**SUBJECT: LOWER NAHIKU BRIDGE HEALTH AND SAFETY
CONCERNS (NAHIKU) (IEM-10)**

Subject: **Nahiku Bridge Structural Assessment
Lower Nahiku Road near Hana Highway, Route 360 M.P. 25
Maui, Hawaii**

Subject: Nahiku Bridge Condition Assessment No. 2
Lower Nahiku Road near Hana Highway, Route 360 M.P. 25
Maui, Hawaii

PHOTO 6 Wood rot in base of upstream pier column

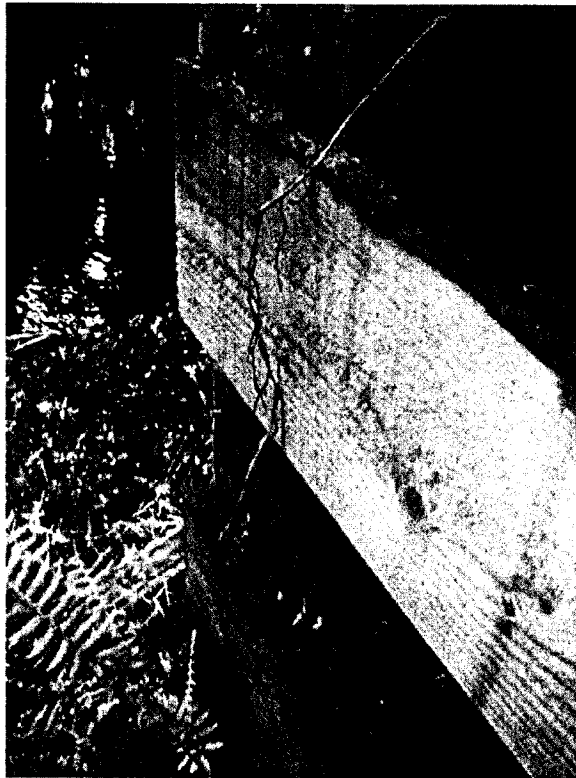
3. The built-up pier cap 6 x 12 timber beams generally appear to be in fair condition.
4. The built-up 6 x 12 timber pier columns generally appear to be in poor condition. One of two 6 x 12 members at both the upstream and center columns is rotted at the base (see Photo 6). The upstream pier column does exhibit a slight curvature in the plane of the pier. Both members of the downstream column is severely rotted at the base (see Photo 7). However, no signs of crushing, settlement, or other obvious vertical movement in the downstream column, cap beam or superstructure were observed.

3. Recommend load posting (or vehicle weight limit) warning signs be installed at both ends of the bridge.
4. Short-term temporary shoring and repair:
 - a. Immediately shore and brace the timber pier structure until the severely damaged elements such as the timber columns, diagonal bracing and timber connection plates are properly repaired or replaced. The temporary shoring and bracing should be installed if the bridge is currently being used.

PHOTO 3 MAUKA SPAN

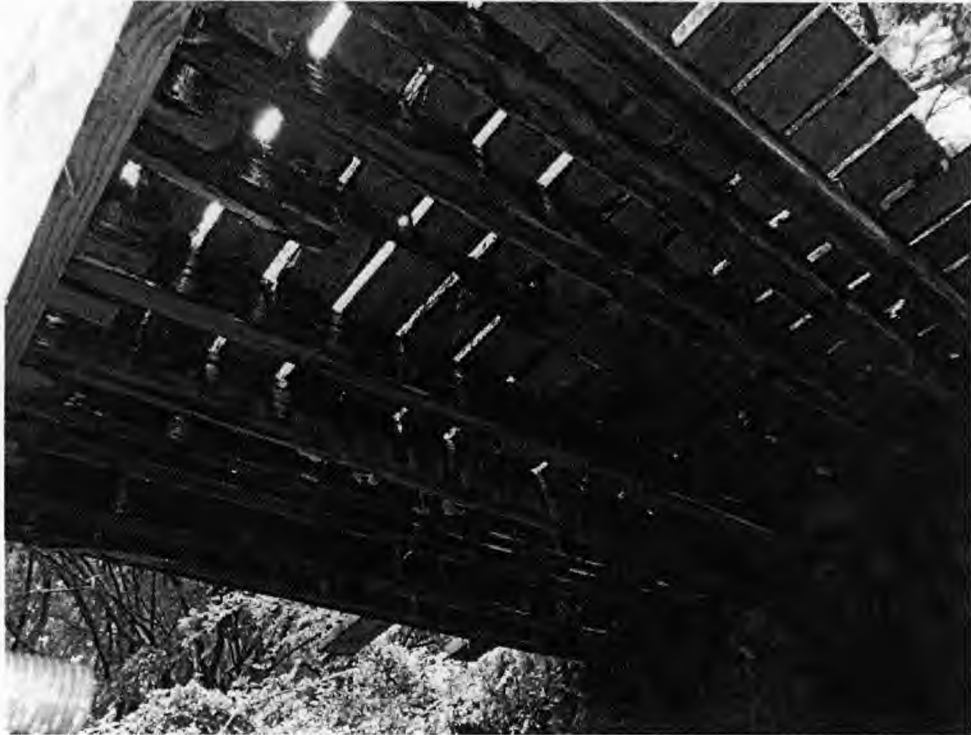
3. 6 x 12 Girders: The ten 6 x 12 timber girders in the mauka span are in poor to critical condition. The fourth girder from the upstream side of the bridge has failed and is no longer there (Photos 3). The bottoms of the timber girders bearing on the pier and mauka abutment and the tops of the girders where the deck planks bear on them are severely decayed. Probes with a metal rod were able to penetrate up to 6 inches into the timber girders.

- 3. Due to the deteriorated condition of the timber members, consideration should be given for a bridge replacement instead of repairing the existing bridge.

PHOTO 6 CONCRETE PIER WALL

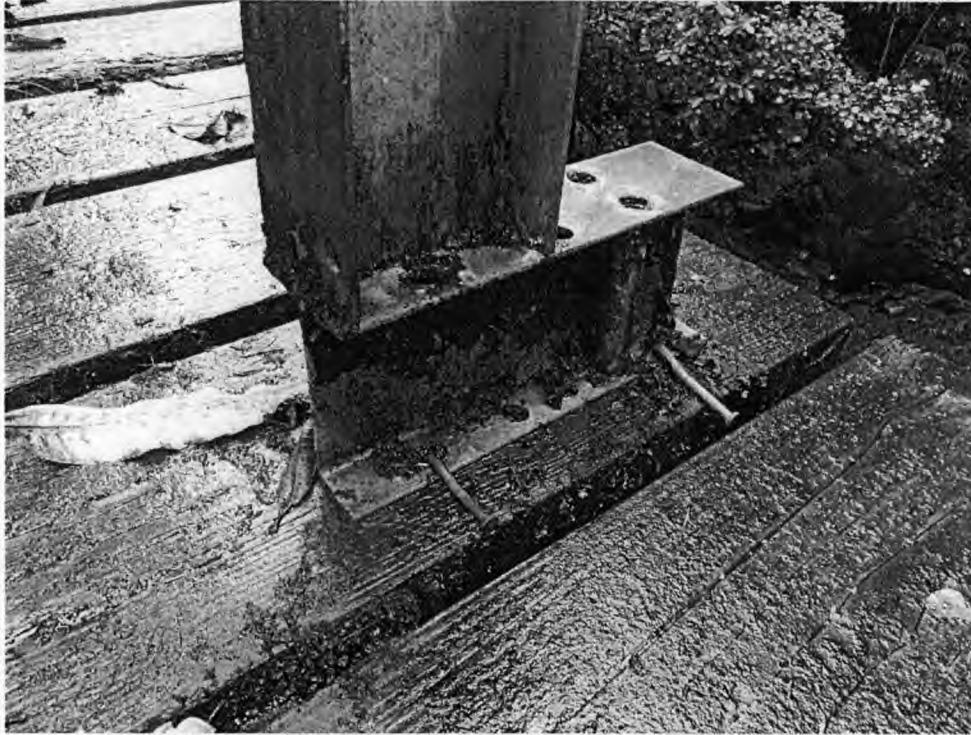
- d. Pier Wall: The concrete pier wall is in fair to poor condition. Honeycombing and heavy scaling has resulted in section loss (Photos 6). We suspect the concrete pier base wall is unreinforced concrete.

PHOTO 9 SEVERE DECAY AT UPSTREAM END OF TIMBER PIER CAP BEAM

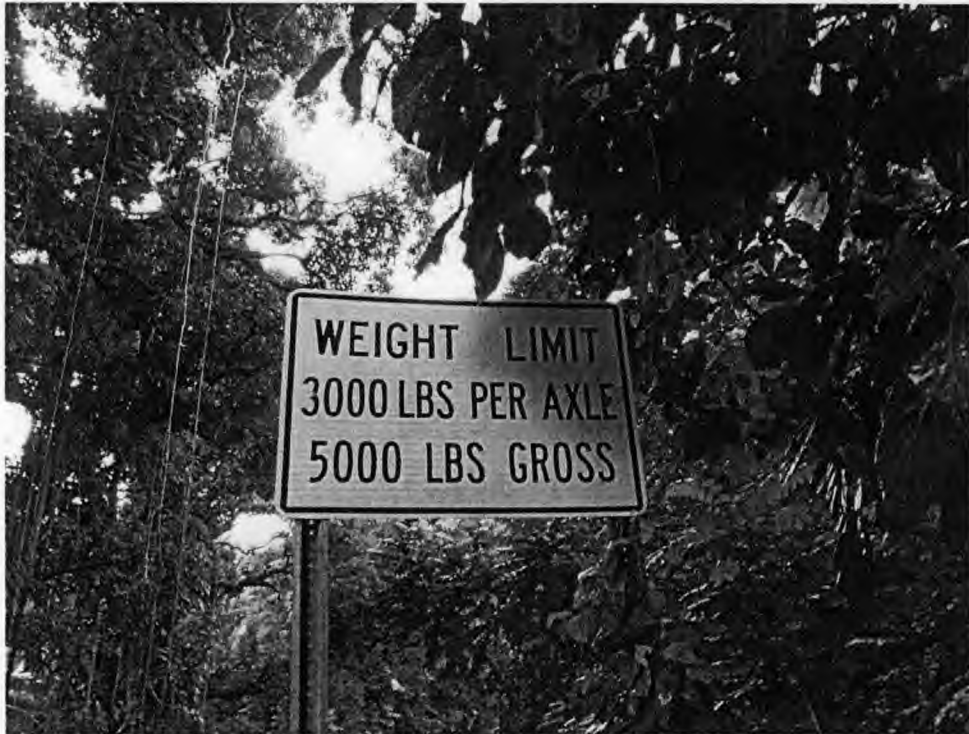
4. Timber Framed Pier:
 - a. Pier Cap Beam: The double 6 X 12 pier cap beams is in fair condition. The upstream end however is the severely decayed and we suspect it is

progressing down the length of the timber cap beams (Photos 9).

- b. Pier Columns: The timber pier columns are in fair to poor condition (Photos 5, 6, 10 & 11). The decayed 6 x 12 members reported in the previous September 12, 2011 assessment has been augmented with additional 6 x 12 timber members at all three pier columns. The timber plates, upon which the columns bear, are severely decayed (Photos 11 & 12).
- c. Pier Braces: The severely decayed 4 x 12 diagonal timber brace members reported in the previous September 12, 2011 assessment has been replaced with a 4 x 12 timber members (Photos 5). The braces are in satisfactory condition.

- 2. Assuming the deteriorated timber members the bridge are repaired and restored to its original as-built condition, the gross vehicle weight limit could be increased to a maximum of 6,000 lbs., or a maximum axle load of 4,000 lbs., whichever is smaller. The repairs should also include seismic retrofit of the timber bridge to meet current code.
